ASSESSMENT REPORT

Cadia East Gold/Copper Project

Cadia Hill Pit Tailings Deposition Modification (06_0295 – MOD 11)

Figure 3: Groundwater levels during operations and post mining recovery

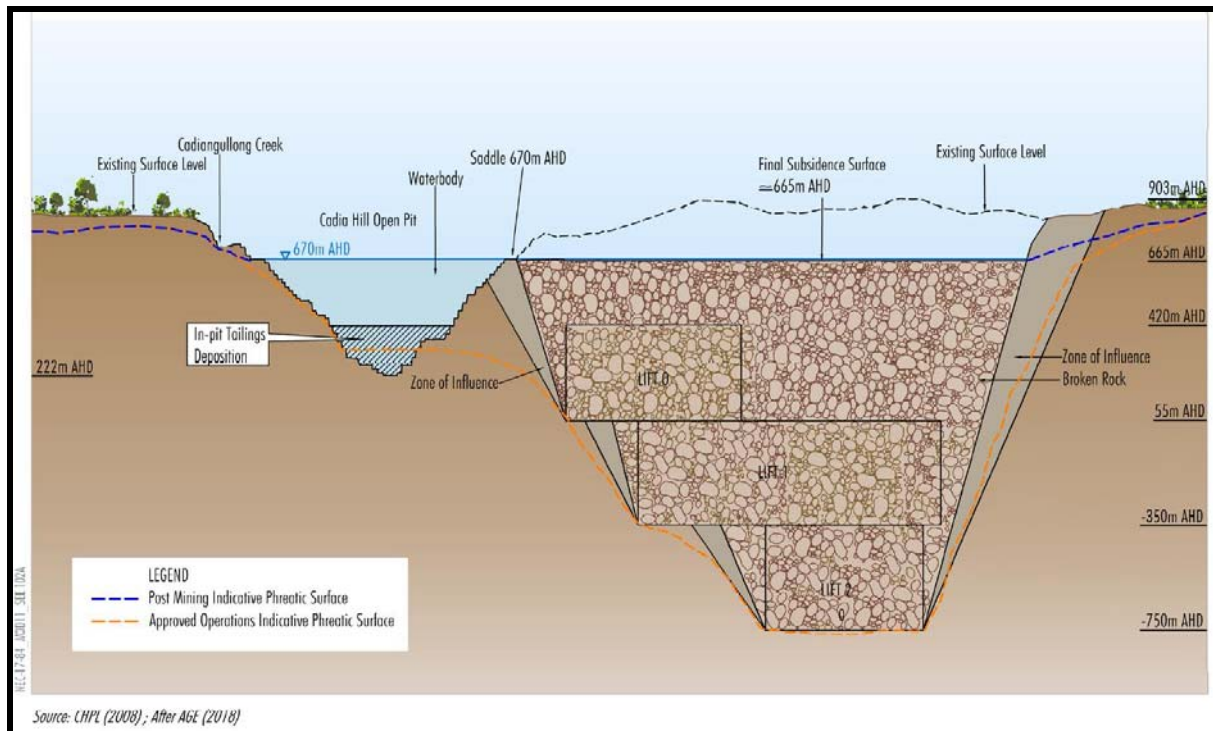
This occurs because groundwater from the surrounding rock flows into the open cut, the underground mining panels and the voids/fractures formed from subsidence of the land over the cave mining area. Once mining is completed, groundwater levels are predicted to recover until a new equilibrium is reached and a pit lake would form, with a direct hydraulic connection between the open cut pit and subsidence void (see **Figure 3**).

This very low permeability is supported by the low groundwater inflow observed seeping into the pit and the high pore water pressure measured close to the pit wall. This is shown in **Figure 3** above where the groundwater or phreatic surface during mining operations is maintained near the void wall. It is estimated from groundwater modelling that there is currently around 0.7 megalitres (ML) of seepage into the pit daily.
